TECHNICAL MEMORANDUM

RE: **EMERGENCY ACTION AMENDMENT
STORMWATER TRUNK LINE CLEANOUT AND REPAIR
NORTH MARINA AMERON/HULBERT SITE
EVERETT, WASHINGTON**

PORT OF EVERETT
AMERON - HULBERT SITE
TRUNKLINE STORM DRAIN REPAIR
TITLE SHEET

DWG. NO.	C1.1
CIP NO.	3-0-0-12-03
PROJECT NO.	PD-NM-2013-09
SHEET NO.	7 OF 8

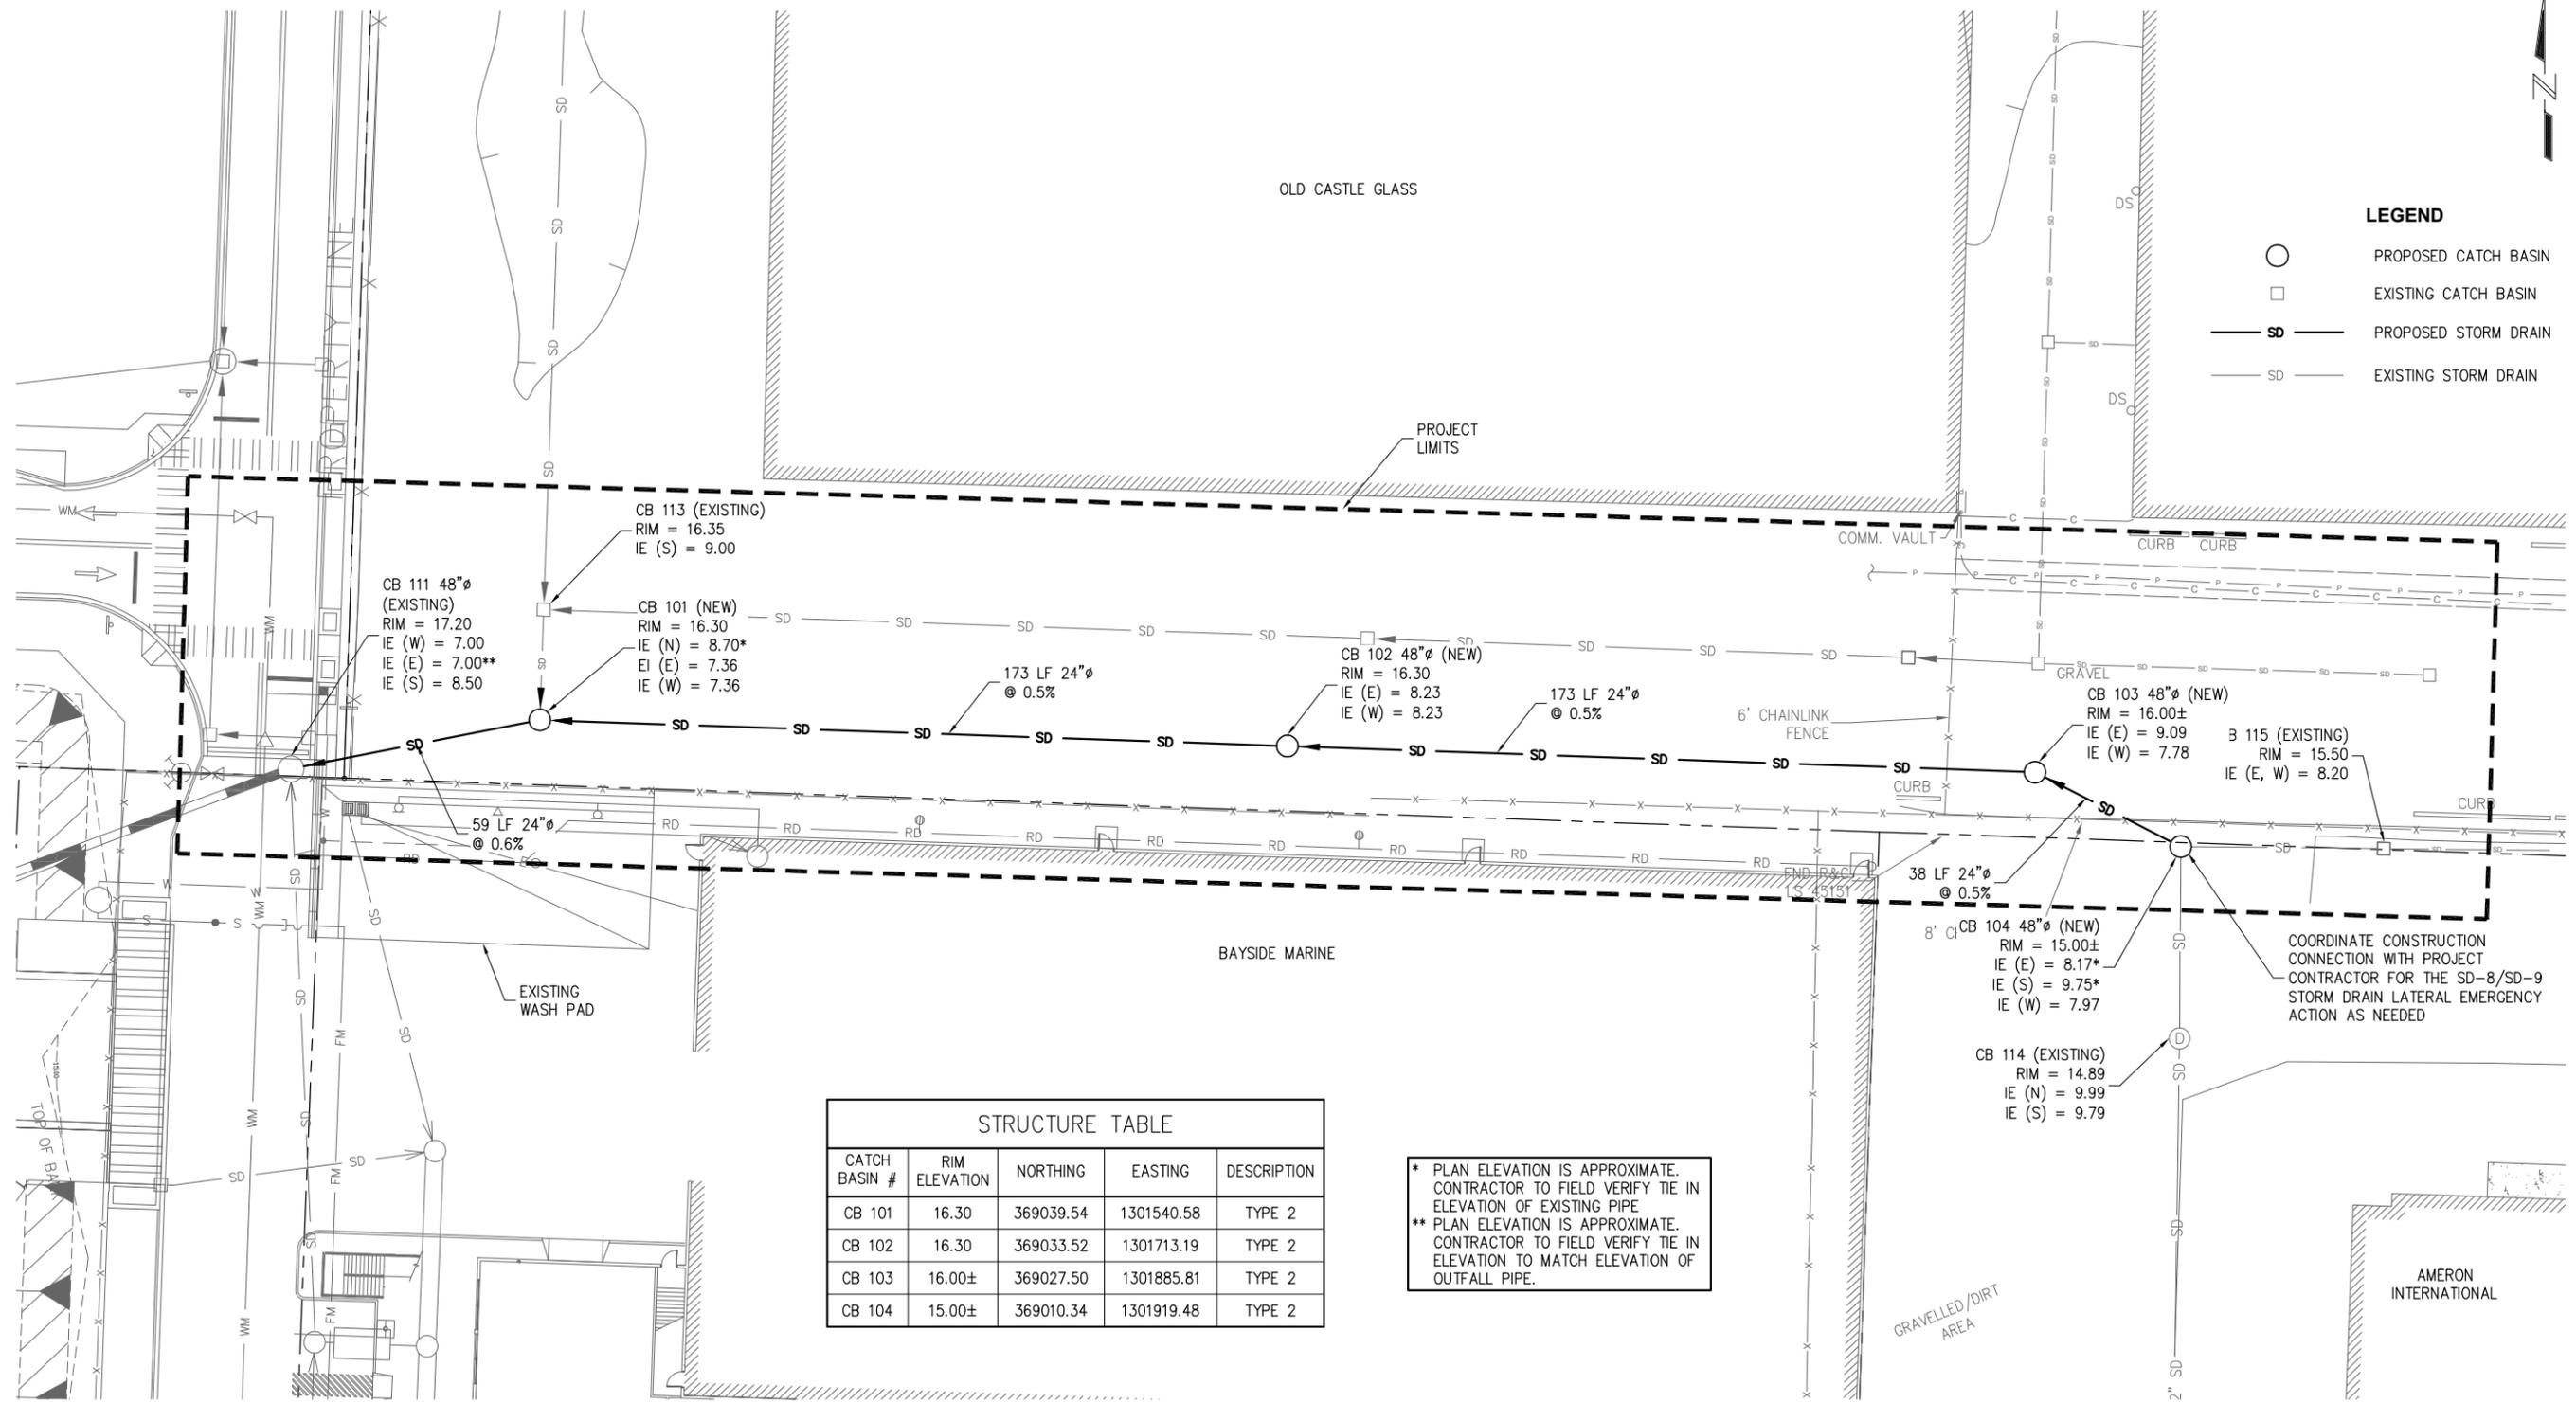
The planned emergency action was presented in a September 19, 2012 technical memorandum (Landau Associates 2012) and was authorized by Ecology in a September 19, 2012 letter. The original plan called for slip-lining the trunk line with Cured-In-Place-Pipe (CIPP) after accumulated stormwater solids were removed from the existing corrugated metal pipe (CMP) trunk line. However, video inspection of the trunk line following cleaning revealed that the CMP had deteriorated to the point that CIPP could not be used to slip-line the trunk line. It was also discovered that one of the sections of trunk line is 18 inches in diameter instead of the 24-inch diameter previously reported, which significantly limited the capacity of a slip-lined repaired trunk line. Based on these considerations, and a concern that installing the trunk line along the current alignment could threaten the stability of the Bayside Marine building, the Port, in conjunction with Norton Industries, is now proposing to construct a new trunk line to the north of a portion of the existing trunk line using conventional trenching construction methods and to remove and replace a portion of the existing trunk line. As part of this proposal, the portion of the existing trunk line located between catch basin CB-111 and the point where the SD-8 lateral connects to the trunk line would be abandoned by injecting it with grout to ensure it does not collapse or function as a preferential pathway for contaminants and a new trunk line would be constructed to the north of this segment. The portion of the existing trunk line located between the SD-8 lateral connection and catch basin SD-5 would be removed and replaced as part of the final cleanup action for the Site (as part of cleanup area G-2). This technical memorandum addresses the portion of the trunk line located west of the

SD-8 lateral connection. Plans and specifications for replacement of the portion of the trunk line located east of the SD-8 lateral connection will be addressed in the Cleanup Action Plan for the Site.

The new trunk line alignment is shown on Drawing C1.1 (Attachment 1). The new trunk line will be constructed of 24-inch-diameter HDPE pipe and will be connected to all stormwater laterals currently served by the existing trunk line. The plans and specifications for the new trunk line construction are included as Attachment 1 to this technical memorandum.
